Product Change Notice – HS25-50 – new tooling

HS25 – 50 current – above

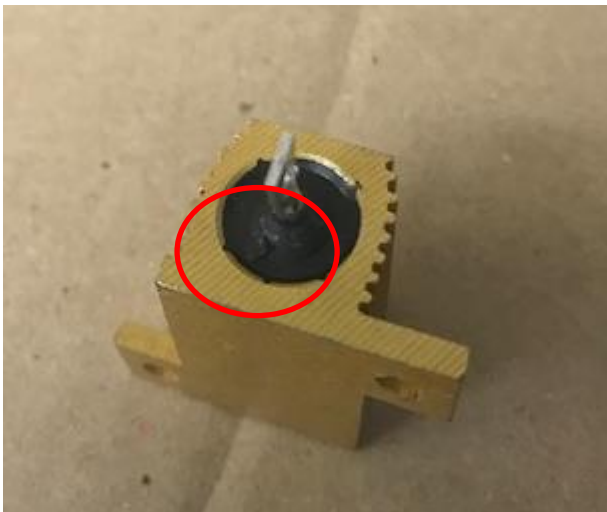
ARCOL UK Limited are notifying their customers that a difference in appearance maybe noticed on the resin face.

The changes are due a process change in moulding and do not adversely affect form / fit or function of the part. This is a visual change only affecting the shape and position of the resin feeder.

This will not affect all HS25 -HS50, only the batches which are moulded with the new tooling.

HS25 - 50 - moulded using new tooling
